L-2003-234
10 CFR 50.54(f)

NRC Bulletin 2003-02
Leakage From Reactor Pressure Vessel Lower Head Penetrations
And Reactor Coolant Pressure Boundary Integrity

Turkey Point Plant Units 3 and 4 Response NRC Bulletin 2003-02

Seabrook Station Response NRC Bulletin 2003-02

Figure 1: Turkey Point Unit 3 BMI penetration # 35 at the vessel interface during 2003 RFO. Note clean insulation surrounding the penetration and no boron deposits or accumulation.

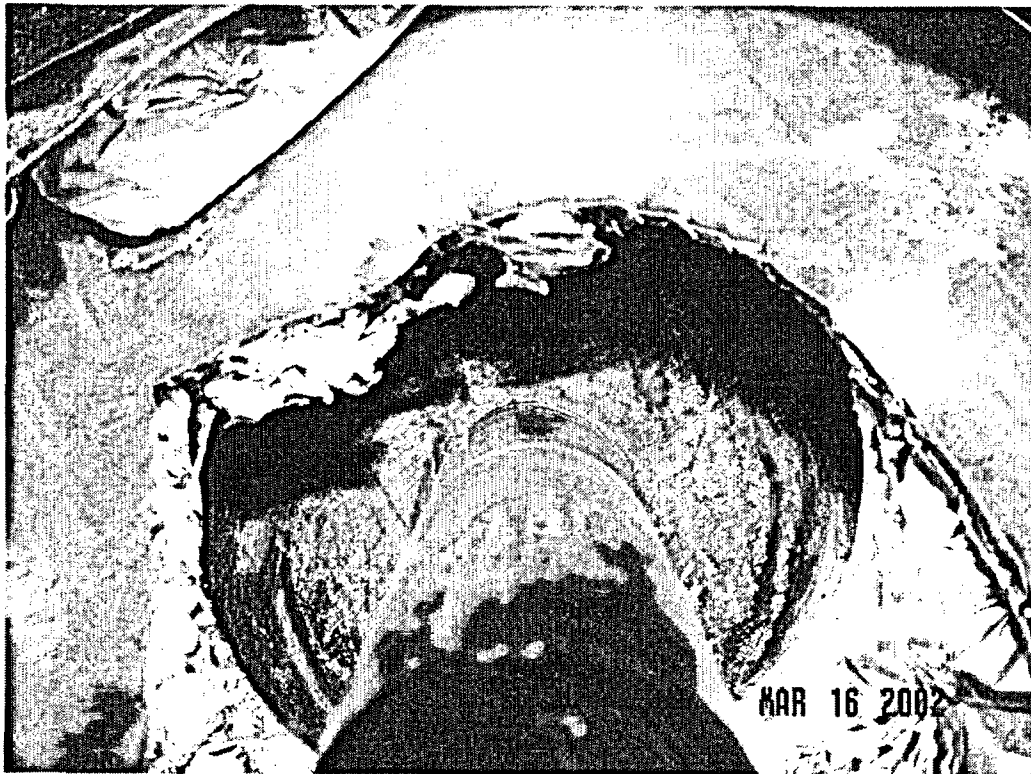
***NRC Request 1(a):** A description of the RPV lower head penetration inspection program that has been implemented at your plant. The description should include when the inspections were performed, the extent of the inspections with respect to the areas and penetrations inspected, inspection methods used, the process used to resolve the source of findings of any boric acid deposits, the quality of the documentation of the inspections (e.g., written report, video record, photographs), and the basis for concluding that your plant satisfies applicable regulatory requirements related to the integrity of the RPV lower head penetrations.*

During the Turkey Point Unit 3 spring 2003 RFO, the leak inspection walkdown of the BMIs revealed a minor discoloration on BMI # 35. A condition report was written as required by our corrective action program. As part of the disposition, insulation cover plates were removed around BMI penetration # 35 to reveal the interface where the nozzle enters the reactor vessel lower head. A direct visual examination was performed by a qualified VT-2 examiner and documented as part of the corrective action program. Digital images of the examination area were also recorded as shown in the figure below. The stain on both the nozzle and the RV surface was described as a dry rust film of no discernible thickness. The stain trail was observed coming from above this outer periphery nozzle (#35) on the vessel surface. No white boron deposits or accumulation was noted on the vessel surface or around the circumference of the nozzle as it penetrated the RV surface (see figure below). The source of the rust stain on the RV lower head surface and BMI penetration #35 was determined to be coming from above, most likely cavity seal ring leakage during refueling and not relevant as a BMI leak since there is no heat source to concentrate boric acid. Similar staining was also noted on the RV cavity walls below the refueling cavity seal ring. A smear sample was taken of the rust stain to analyze the activation products to determine the age of the stain/leak source. However, due to the stain having no discernable thickness (small sample size) the results were inconclusive.

FPL Response to Request 1(a): As identified in the response to Question 5¹ of the NRC request for additional information on boric acid inspection programs, previous inspections of the bottom mounted instrumentation penetrations (BMIs) at Turkey Point Units 3 and 4 have been performed as part of the ASME Section XI system leakage test walkdown performed at every (18 month) refueling outage (RFO) with the system at normal operating pressure and the insulation in place. These walkdown inspections are performed by procedure and documented on a system pressure test report in accordance with our ASME Section XI program. Although past procedures did not specifically identify the BMI nozzles, the system

pressure tests and boric acid program walkdowns have never identified any BMI leakage. However, minor discoloration was noted at the last Turkey Point Unit 3 RFO that was dispositioned as cavity seal ring leakage as discussed below:
